107 HIGH STREET, LINDFIELD, HAYWARDS HEATH, RH16 2HR

**PART VII | PROPOSED REGULARISATION
OF SCHEME**

The proposed scheme hereunder assessed is a variation of the scheme approved under DM/22/3694 and DM/22/3695, combining elements of the scheme as implemented and other elements, as yet not implemented.

COMPARISON - ROOF PLAN. 1:100@A3

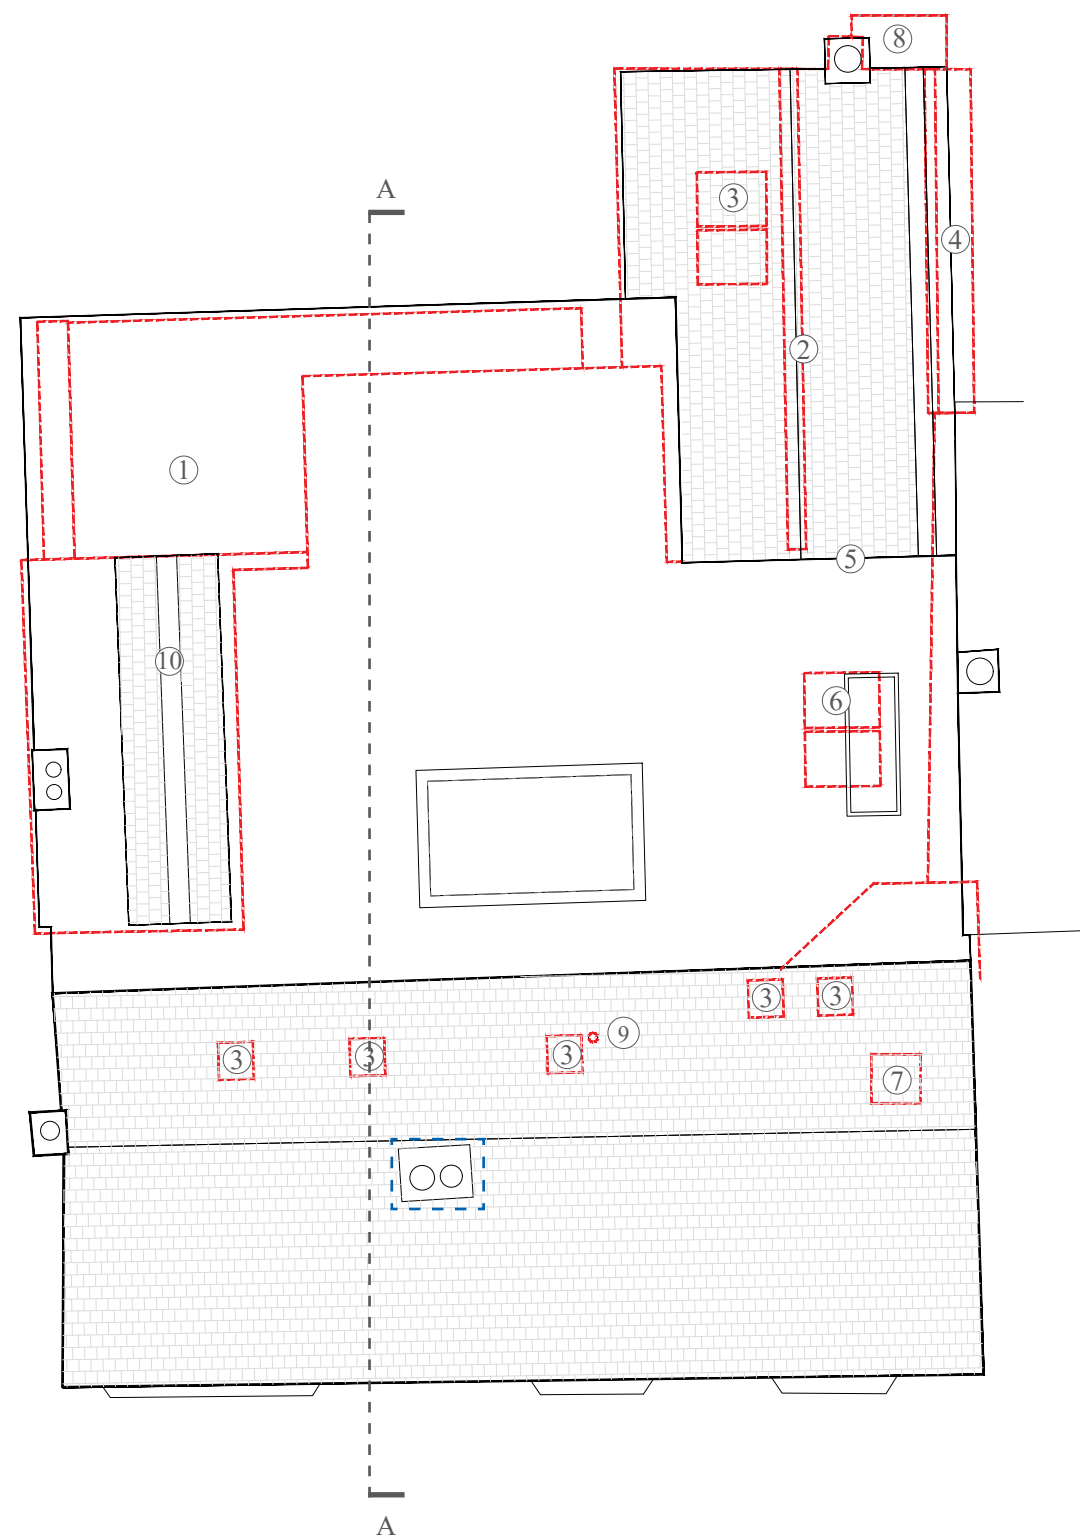
1. Rear extension extended - spanning full width, concealing the historic gable
2. Historic bake house re-constructed following its collapse during strip-out.
3. Rooflights omitted (7no)
4. Gutter design deviates from approved- parapet wall and secret gutter
5. No step between roof planes
6. Single rooflight instead of two
7. Existing chimney removed
8. AC AHU louvred timber enclosure - matching timber of new extension
9. Boiler flue installed
10. Historic gable partially visible above new flat roof

COMPARISON - WEST ELEVATION. 1:50@A3

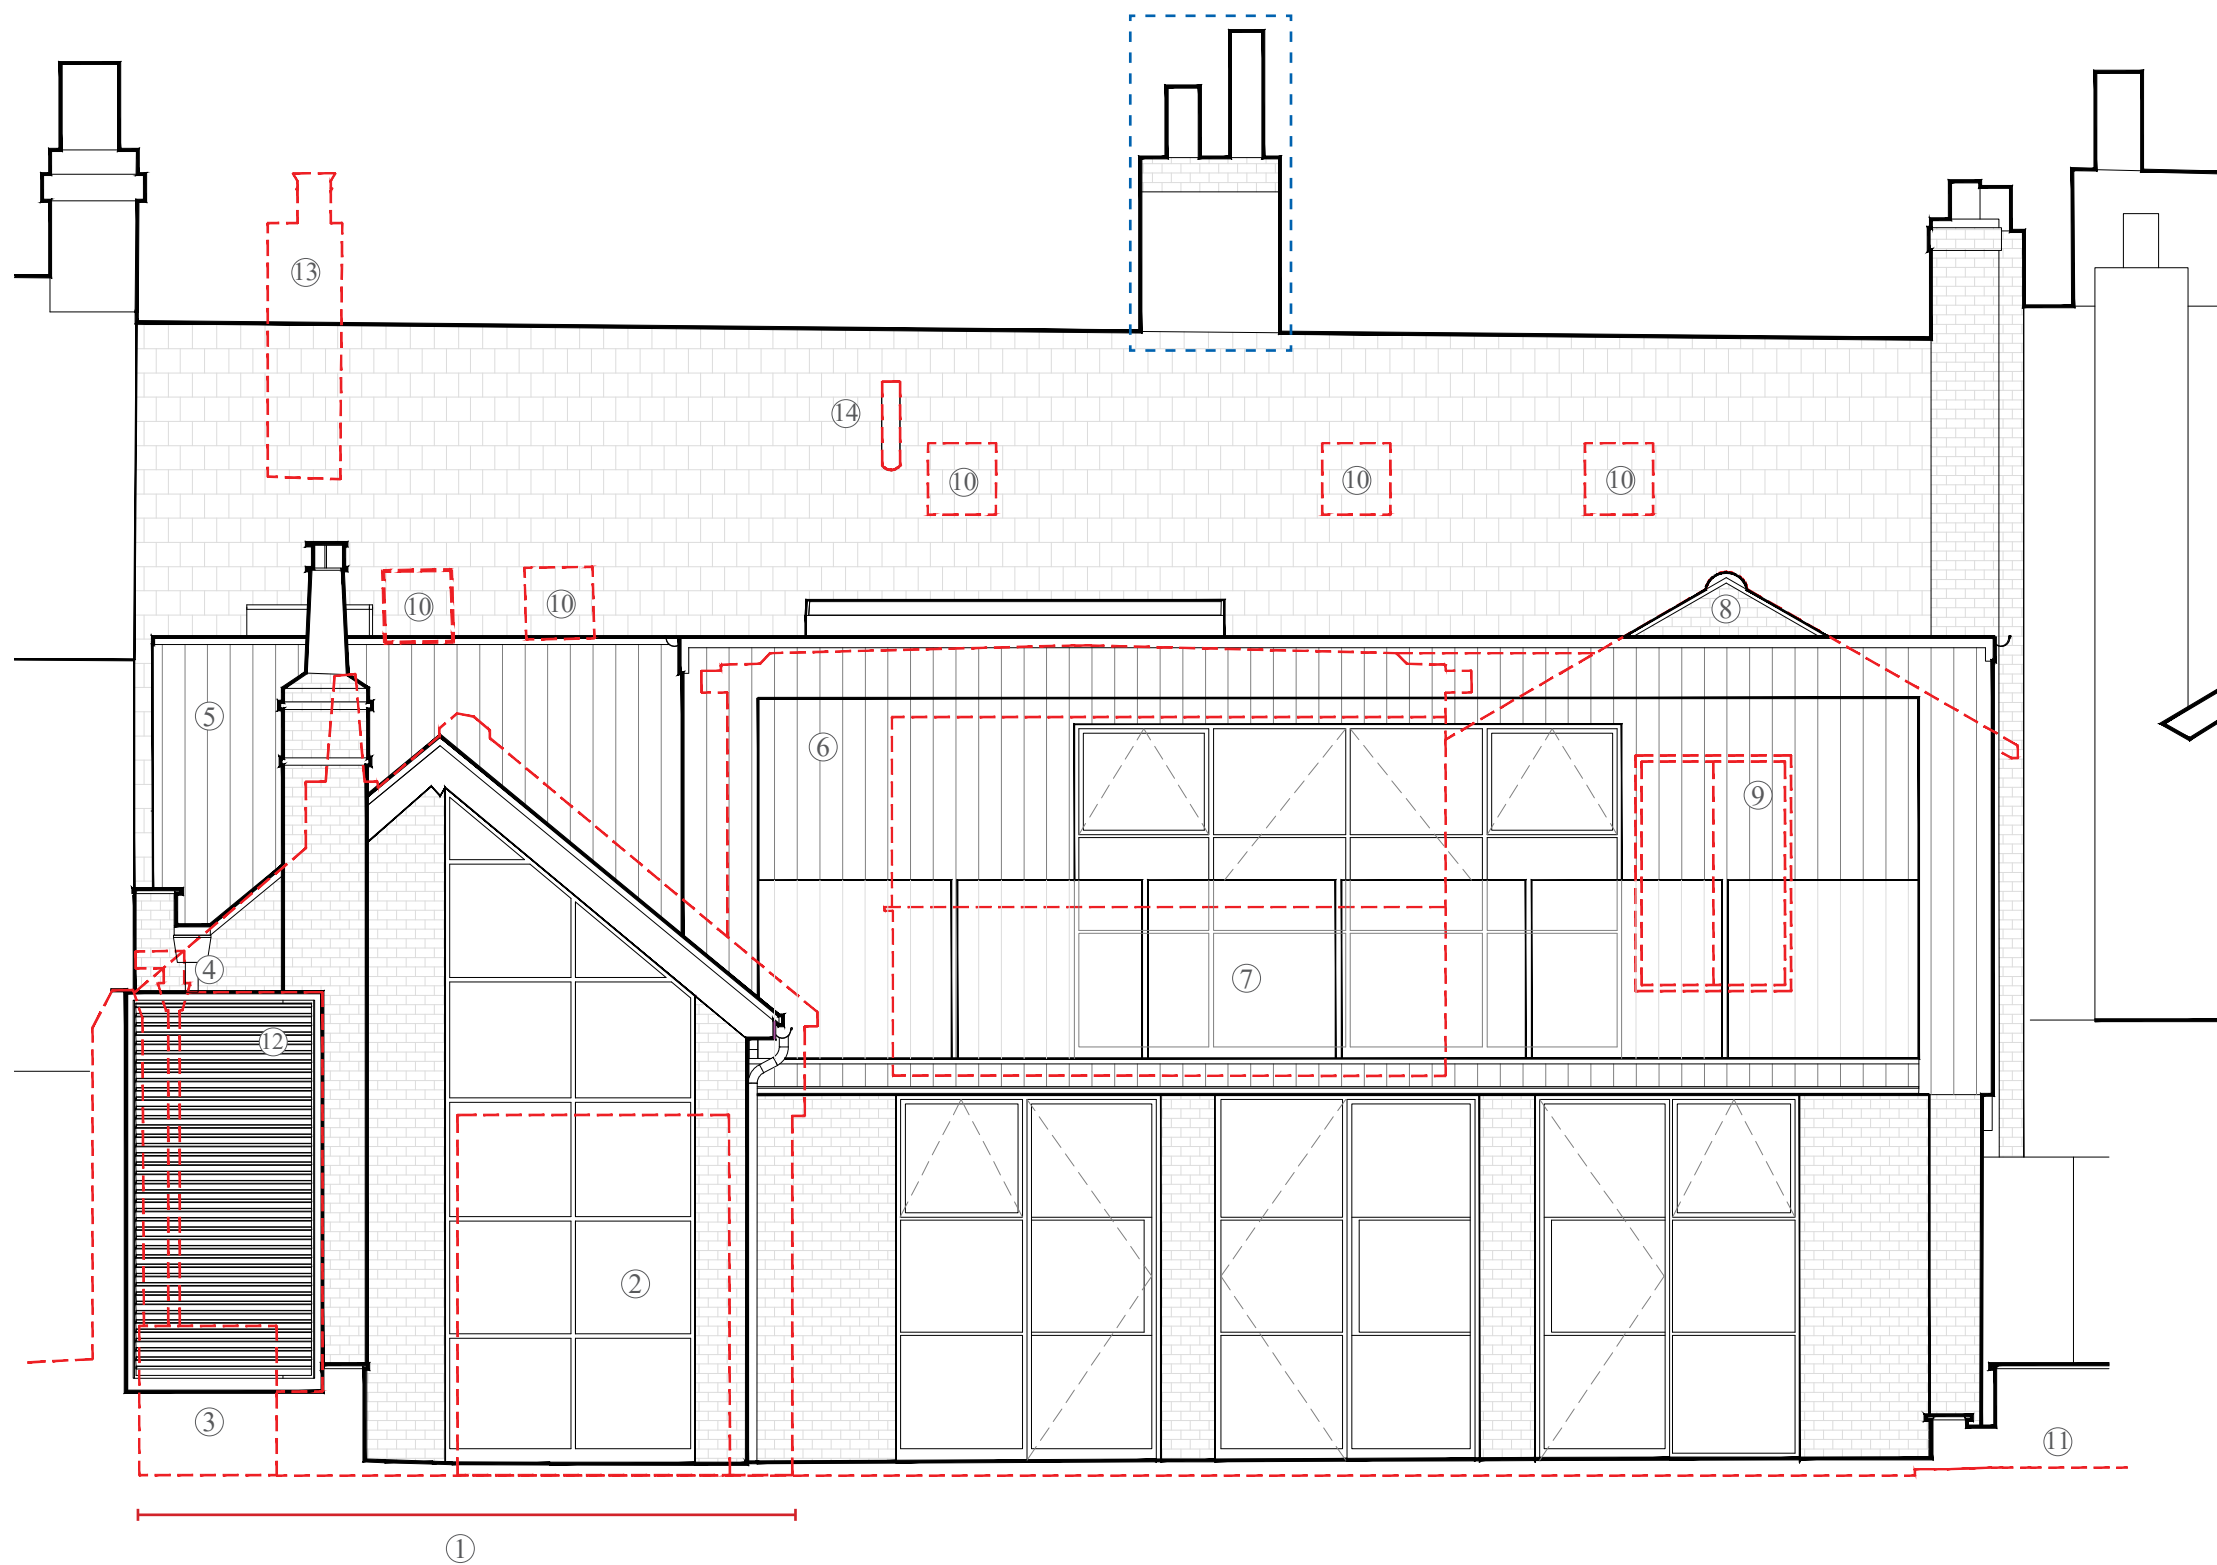
1. Historic bake house re-constructed following its collapse during strip-out
2. Window of different design
3. Raised planter not constructed
4. Gutter design deviates from approved- parapet wall and secret gutter
5. Additional mass, flat roof
6. Rear extension extended - spanning full width, concealing the historic gable
7. Terrace balustrade glazed instead of metal
8. Historic gabled extension retained but hidden behind new rear extension
9. Gothic window retained but hidden behind new rear extension wall
10. Rooflights omitted
11. Landscape design deviates from approved
12. AC AHU louvred timber enclosure - matching timber of new extension
13. Existing chimney removed
14. Boiler flue

COMPARISON - SOUTH ELEVATION. 1:50@A3

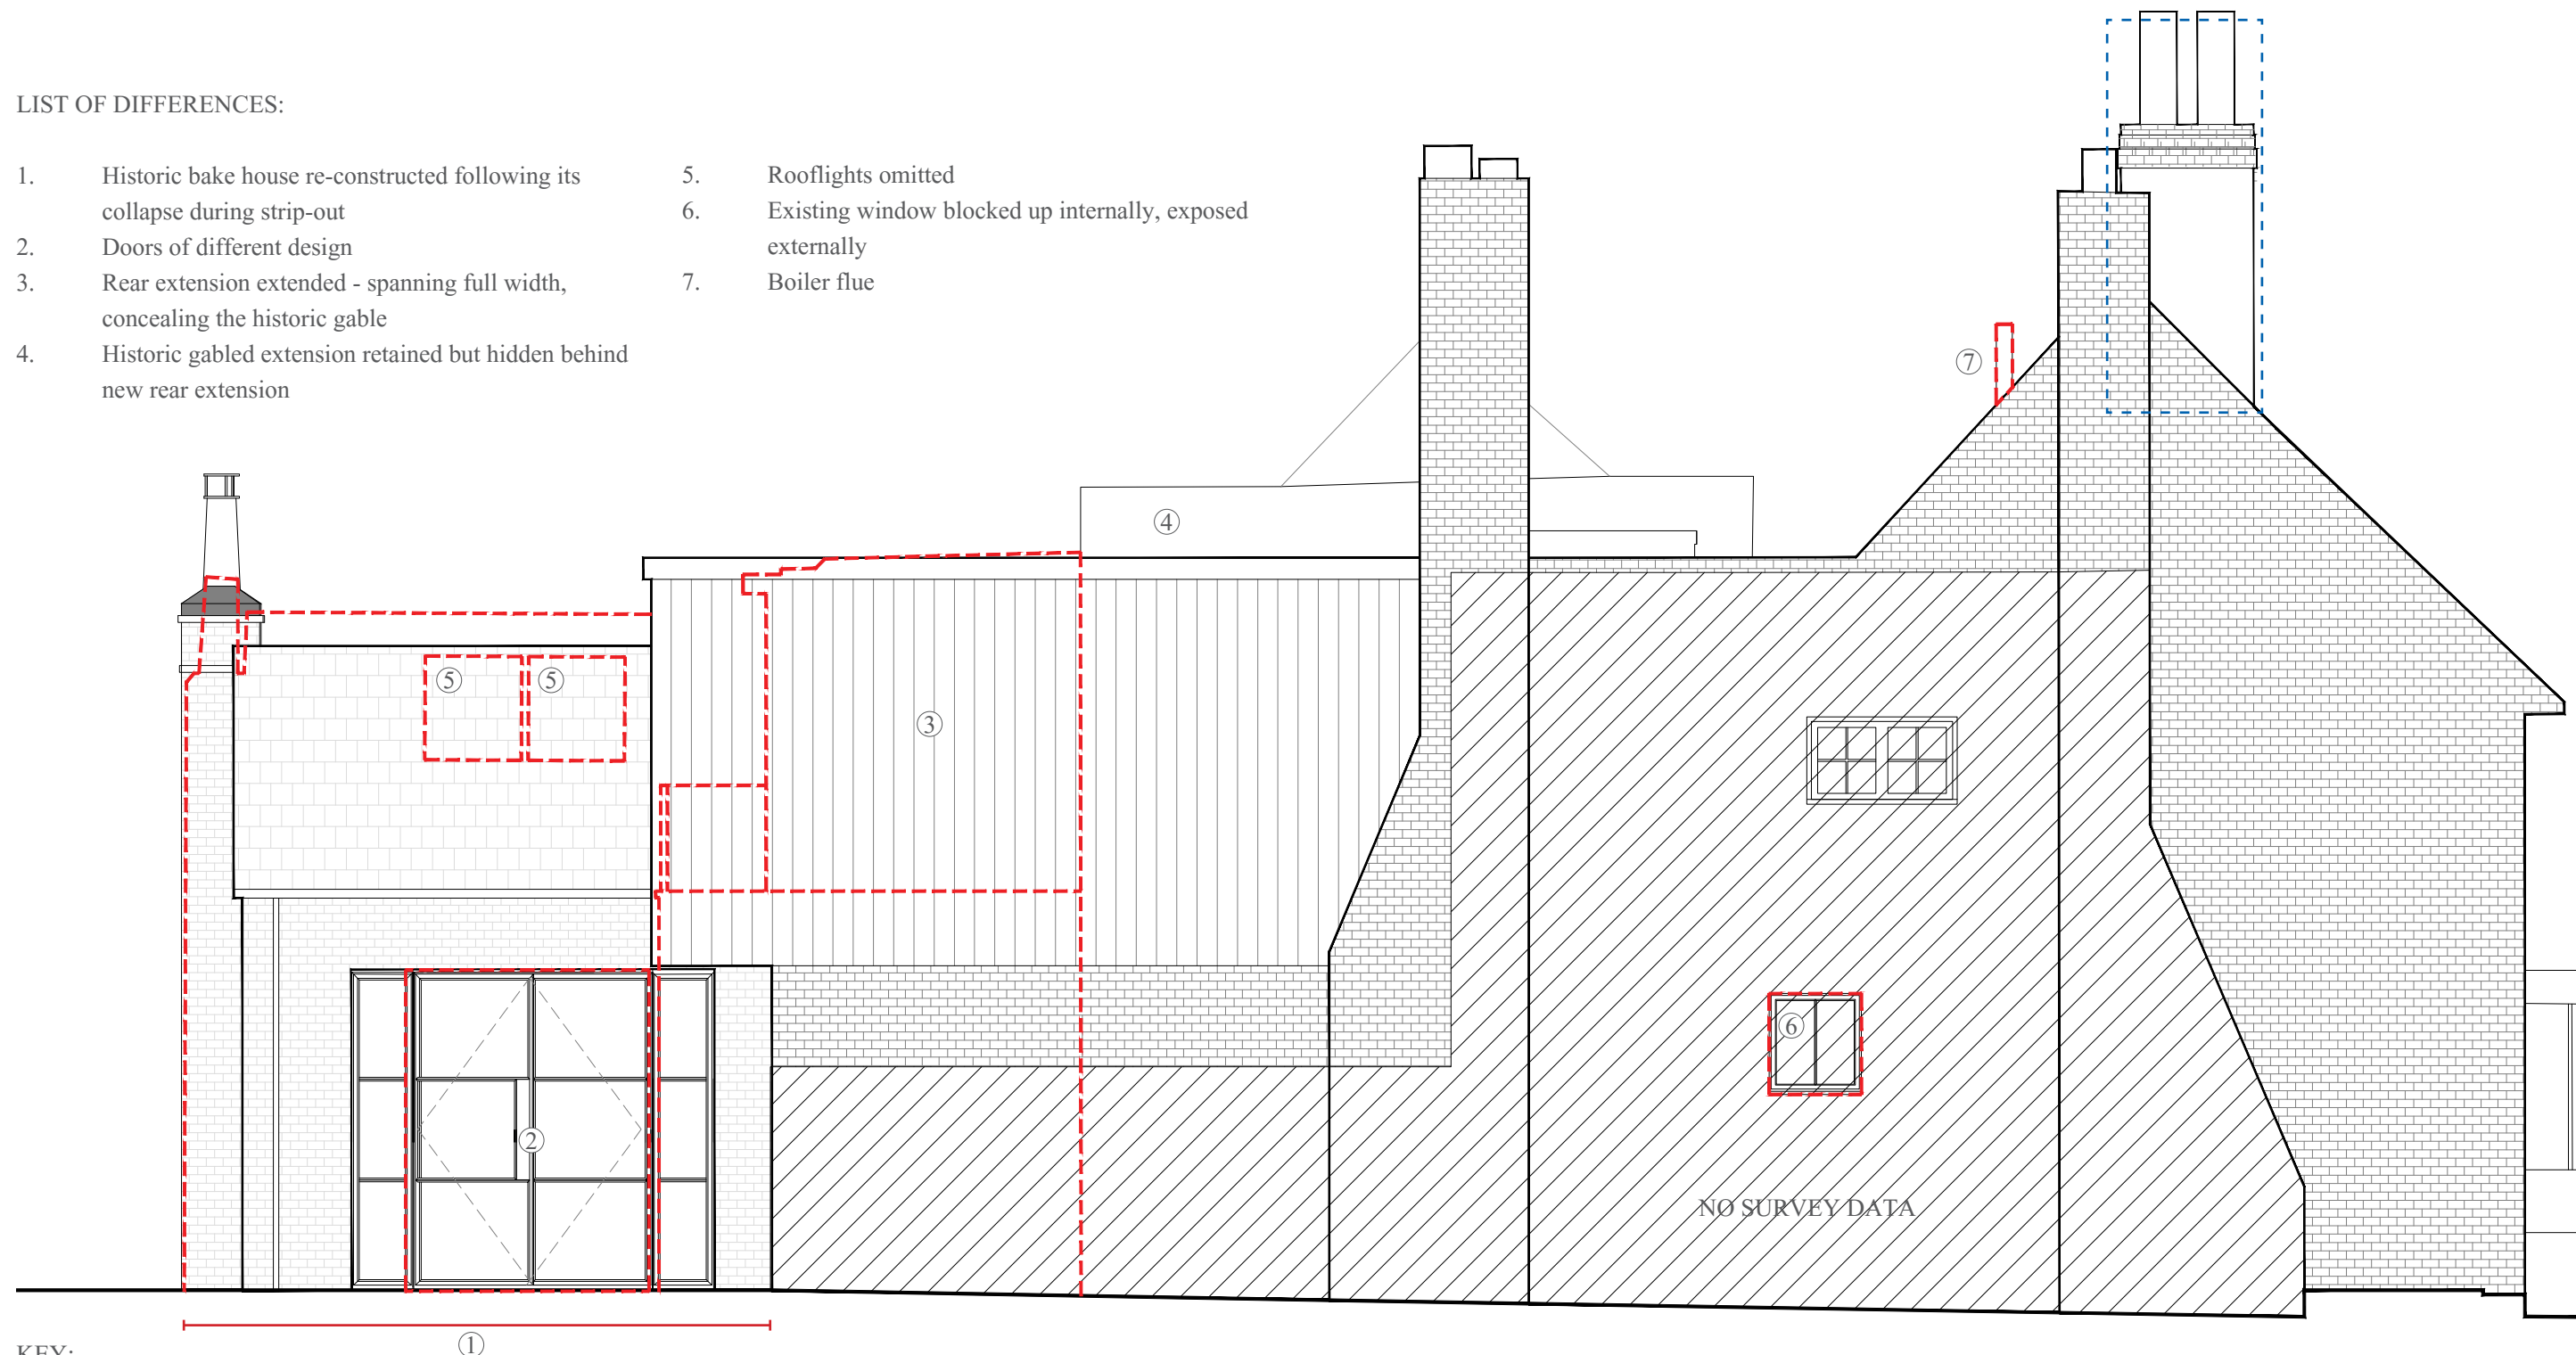
| 1. | Historic bake house re-constructed following its collapse during strip-out | 5. | Rooflights omitted |
| 2. | Doors of different design | 6. | Existing window blocked up internally, exposed externally |
| 3. | Rear extension extended - spanning full width, concealing the historic gable | 7. | Boiler flue |
| 4. | Historic gabled extension retained but hidden behind new rear extension | | |
